DEPARTMENT REPORT

HEARING DATE: 11/06/2025-(Continued from 10/02/2025)

SUBJECT: H-2025-0004
St. George

LOCATION: Located at 3870 E. Overland Road and 1545 S. Topaz Avenue in the SE ¼ of the SW ¼ of Section 16, T.3n., R.1E.

D. Site Plan (date: 7/30/2025)

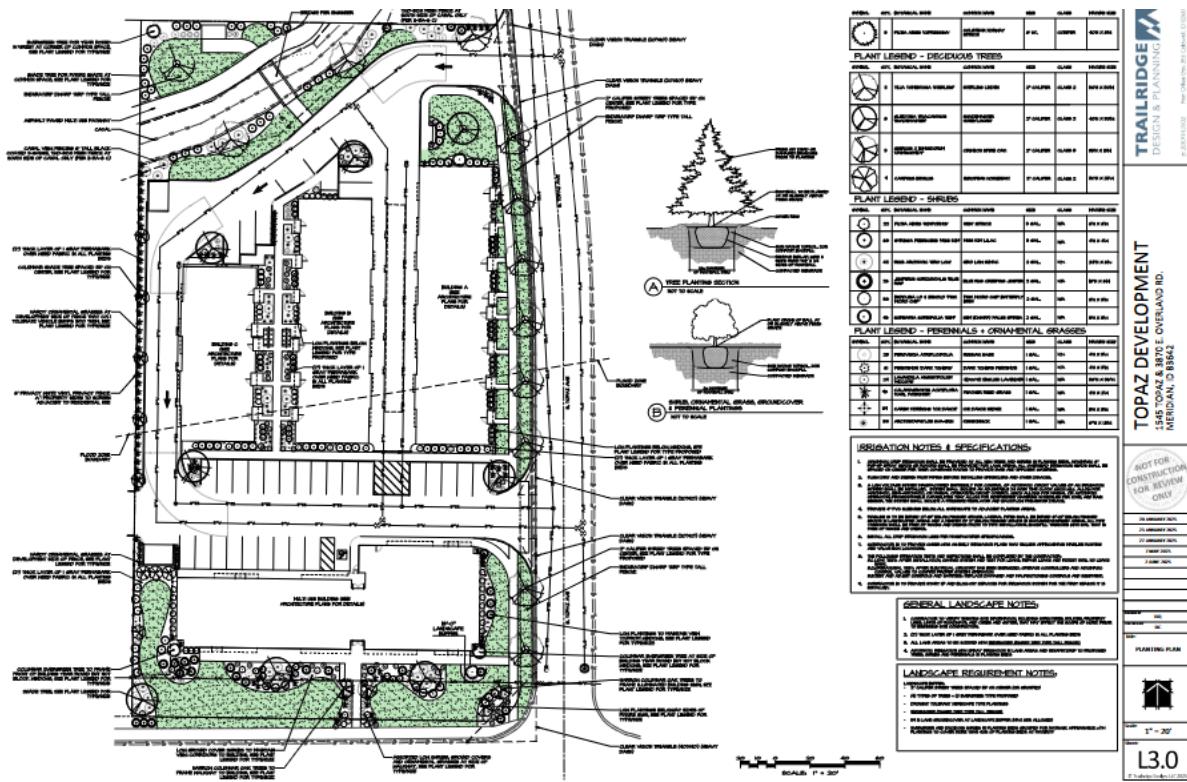
- Water main placement on the west side does not meet the required 4' setback from the curb; inadequate separation from the infiltration trench; fire hydrants not shown, raising easement and spacing concerns; easement area limits the ability to meet landscaping and tree requirements.

- Proposed balconies/porches may encroach into 20' sewer easement; landscaping within the easement is not allowed, preventing compliance with UDC 11-3B-12.

The applicant has worked with staff on several rounds of revisions to try and make the site meet all of the dimensional standards. To meet the drive aisle requirements, the applicant is requesting alternative compliance to reduce the western landscaping adjacent to the 25-foot drive aisle from five (5) feet to two (2) feet.

However, issues persist with landscaping inside of easements. In communication with the Public Works Department, it was determined that a significant amount of proposed landscaping will need to be removed due to easements encumbering the site. Staff is concerned with this as the proposed development will not meet the landscaping requirements in UDC 11-3B due to inadequate room on the site. Staff has discussed losing units on the site to make adequate room for both the easements, separation, and required landscaping. However, the applicant did not indicate whether they would be supportive of losing units to better accommodate the site.

The floor plan depicts 68 square foot patios or decks for each unit that does not comply with this standard. Staff is not supportive of reducing the private usable open space for this project.

In addition, if overflow parking is ever needed, it would push residents and commercial customers to park on Topaz Avenue.

The common open space areas depicted for the development do not meet this requirement. The open space depicted on the south portion of Five Mile Creek does not exceed twenty (20) feet in width.

7. Show accessible pedestrian routes from the buildings to the pathway. Parallel parking on the north side of Building B appears to block pedestrian access to pathway and open space amenity.

E. Landscape Plan (date: 6/2/2025)

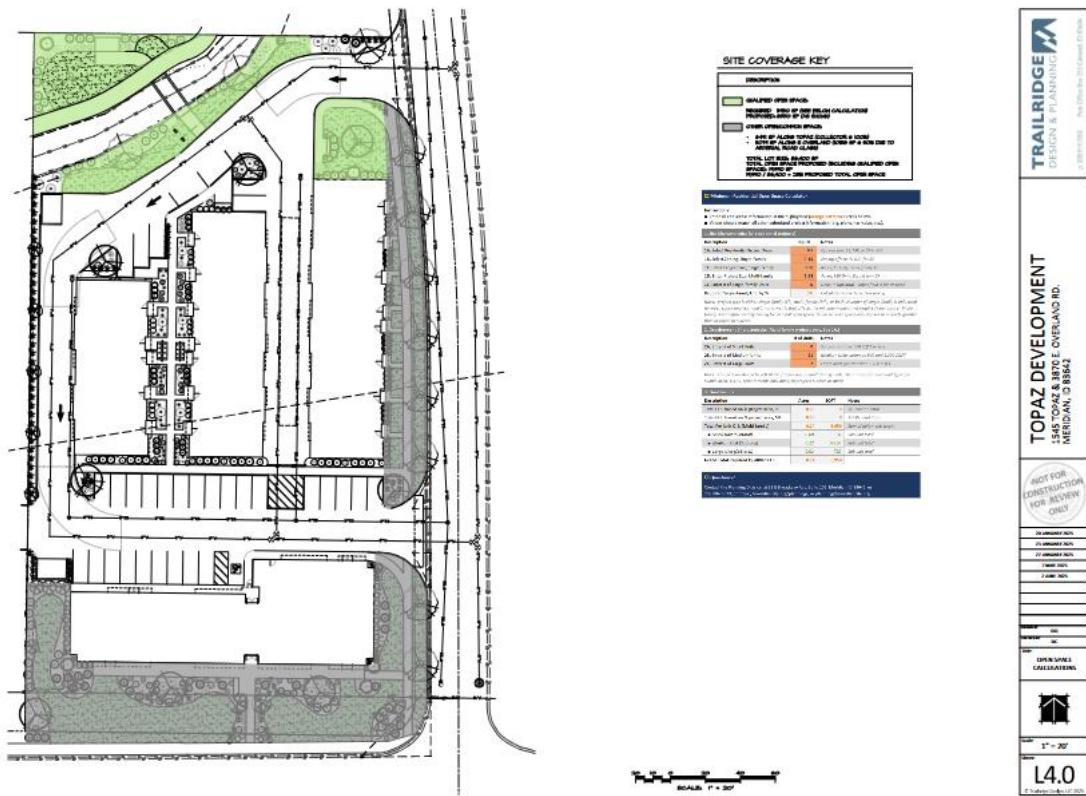
The proposed landscape plan does not meet this requirement. The water conserving design standards have not been met, which then does not justify the 50% reduction in the landscape buffer along Overland Road. Without the reduction in the buffer, the applicant does not meet the standards in the UDC.

Landscape is required to be provided along all parking areas per the standards listed in UDC 11-3B-8. *The proposed landscape plan does not meet the minimum requirements. Several planter islands and landscaping areas are missing trees or other vegetation due to easements. The Public Works Department expressed concerns regarding proposed landscaping and easement locations as there is also proposed landscaping*

The landscape plan does not meet the minimum requirements for the zoning being requested. The applicant cannot place trees in the landscaping on the west portion of the site due to a proposed reduction from five (5) feet in width to two (2) feet in width.

The applicant does not meet the pathway landscaping requirements and shall revise their site and landscape plan to reflect compliance with these standards. A minimum of ten (10) feet of landscaping is required along pathways with no less than two (2) feet on any one side.

If approved, the applicant shall provide vegetation coverage calculations with the submittal of the certificate of zoning compliance submittal and shall provide a tree in each planter island. If a tree cannot be placed in a planter island due to an easement, relocation of the tree elsewhere on site will be required.
